CITY PLAN COMMISSION STAFF REPORT

Project Name
4627 Madison Apartments

Request
CD-CPC-2023-00153 (3.2)
Development Plan

CD-CPC-2023-00155 (3.1)
Rezoning

SITE UTILITY PLAN

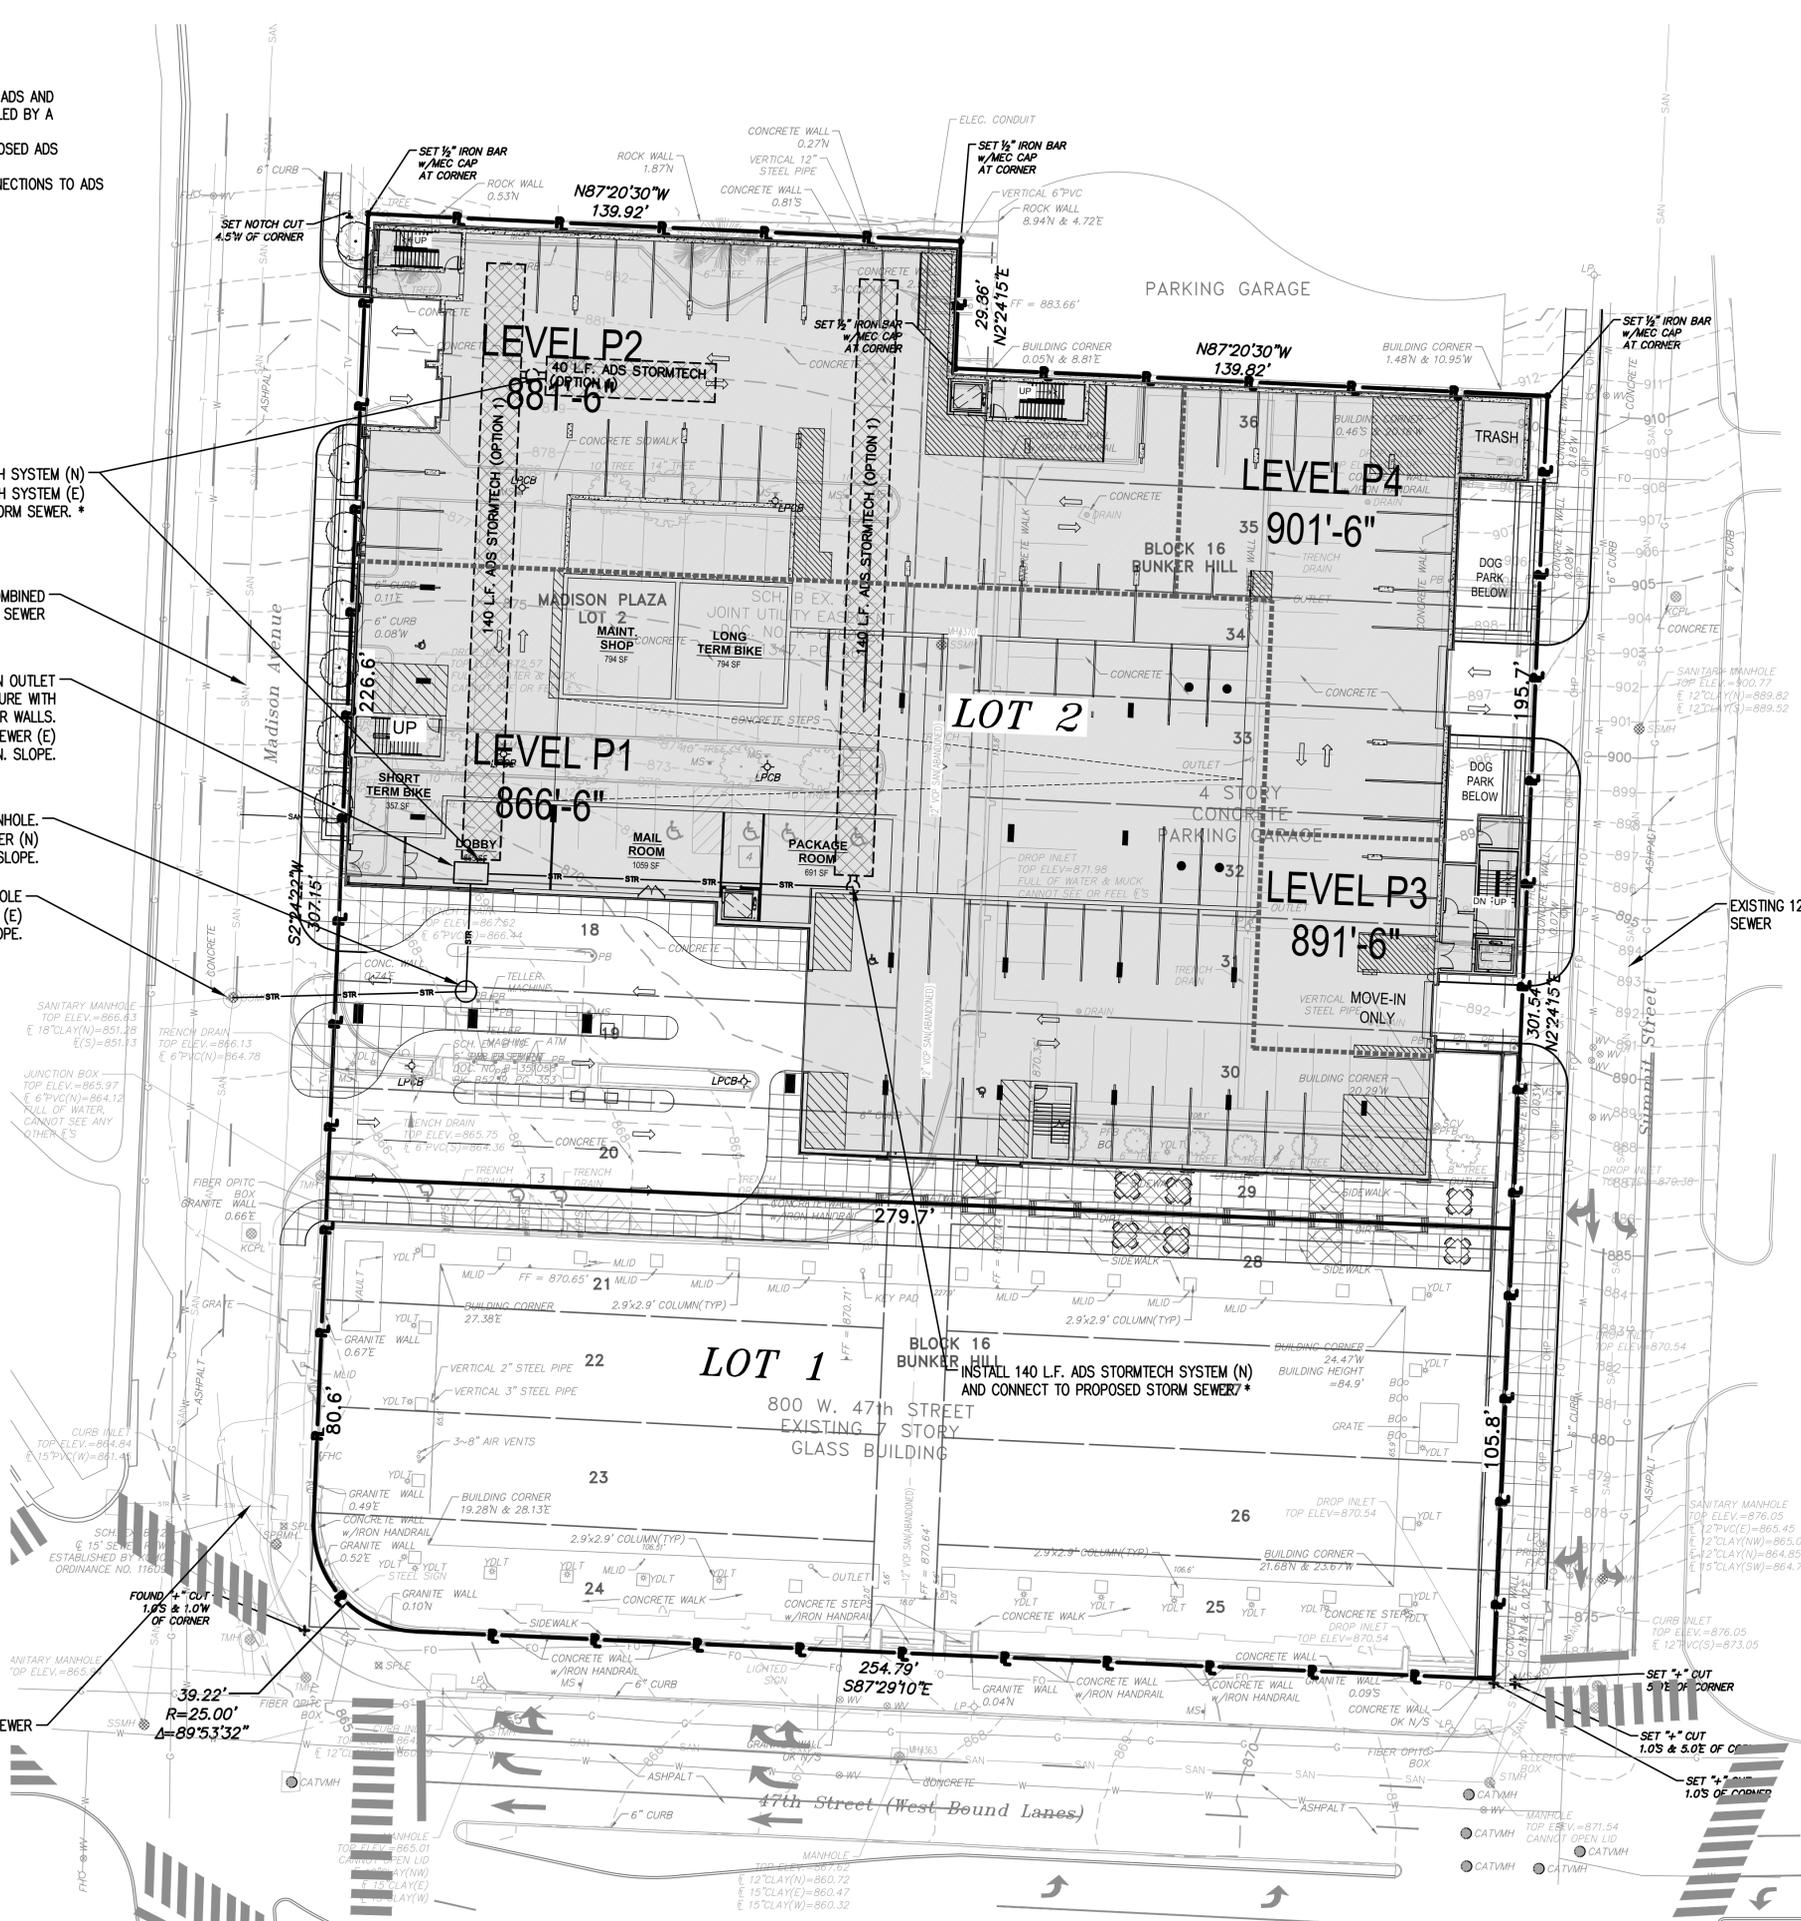
9. Water Services Condition: Provide a Utility Plan showing and labeling the location and sizes of the Existing & Proposed Public Water Mains & Fire Hydrants. Condition must be revised prior to City Council Ordinance Request.
Note 10/30: Sheet C1.01 Utility Plan not modified per previous comments and response letter for proposed fire and domestic water connections to the 8" main in 47th Street vs. 6" main in Madison Ave. (The 8" main will still need to be verified as adequate).

22. Per the utility plan note to connect the proposed private domestic and fire service lines to the existing 6" public water main in Madison Ave., this main is not likely adequately sized for these connections and providing for the existing water flow demands. The existing water main in Madison Ave. is slated for upsizing and replacement as part of the WSD water main replacement program, however the timing of the two projects is unknown, and the new main would need to be in service prior to connecting. An 8" main exists in 47th Street according to our GIS maps and is more likely to be able to provide adequate flows and pressures for the domestic and fire flows and would need further investigation for confirmation of available flows and pressures vs. anticipated demands. If these options are not viable then a main extension and upsizing project will be needed.
